Access Compliance Report Public Rights-of-Way (Curb Ramps)

Main Street: LA_COLINA_DR Cross Street: N/A Location: S

ADA ID: RPRK220125115251 Ramp Type: Type 1 - Perpendicular Diagonal Initial Pass/Fail: Fail Overall Compliance: No Severity Score: 45

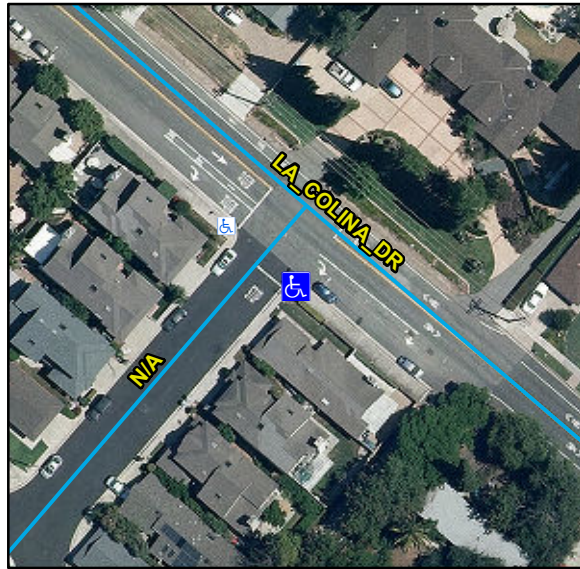
Compliance	Description	Data	Compliance	Description	Data
N/A	Ramp Length (in)	77	N/A	Flare Type LT	
Yes	Ramp Width (in)	54			N/A
No	Ramp Run Slope (%)	13.2	N/A	Flare Slope LT (%)	N/A
No	Ramp Cross Slope (%)	6.8	N/A	Flare Traversable LT	N/A
N/A	Landing Present	N/A	N/A	Flare Type RT	
N/A	Landing Length (in)	N/A			N/A
N/A	Landing Width (in)	N/A	N/A	Flare Slope RT (%)	N/A
N/A	Landing Run Slope (%)	N/A	N/A	Flare Traversable RT	N/A
N/A	Landing Cross Slope (%)	N/A	N/A	DWS Provided	N/A
N/A	Landing Movement Obstructed?	N/A	N/A	DWS Contrast	N/A
	Landing Movement Type	N/A	N/A	DWS Length (in)	N/A
N/A	Landing Shared	N/A	N/A	DWS Full Width	N/A
N/A	Clear Space	Yes	N/A	DWS Offset Left (in)	N/A
N/A	Clear Space To Crosswalk (in)	N/A	N/A	DWS Offset Right (in)	N/A
N/A	Marked Crosswalk 1	No	N/A	Marked Crosswalk 2	No
	Crossing 1 Direction	NE		Crossing 2 Direction	NW
	Marked Crosswalk 1 Width (in)	N/A		Marked Crosswalk 2 Width (in)	N/A

N/A	Ramp Inside Crosswalk 1	N/A	Yes	Ramp Inside Crosswalk 2	N/A
	Crossing 1 Slope (%)	3.5		Crossing 2 Slope (%)	5
	Crossing 1 Cross Slope (%)	0.2		Crossing 2 Cross Slope (%)	4.5
N/A	Gutter Ponding	N/A	N/A	Curb Slope	2.3
No	Gutter Lip Height (in)	0.5		Road Run Slope (%)	1.7
N/A	Gutter Run Slope (%)	N/A		Road Cross Slope (%)	0.3
N/A	Gutter Cross Slope (%)	N/A			
Yes	Overall Surface Condition: Acceptable		No	Perp Joint Present	No
	Cross Gutter Present?	No		Spandrel Present?	No
	Replace Cross Gutter?	N/A		Replace Spandrel?	N/A

Remove & Replace Curb Ramp With Two New Directional Ramps or Equivalent. Grind Gutter Lip.
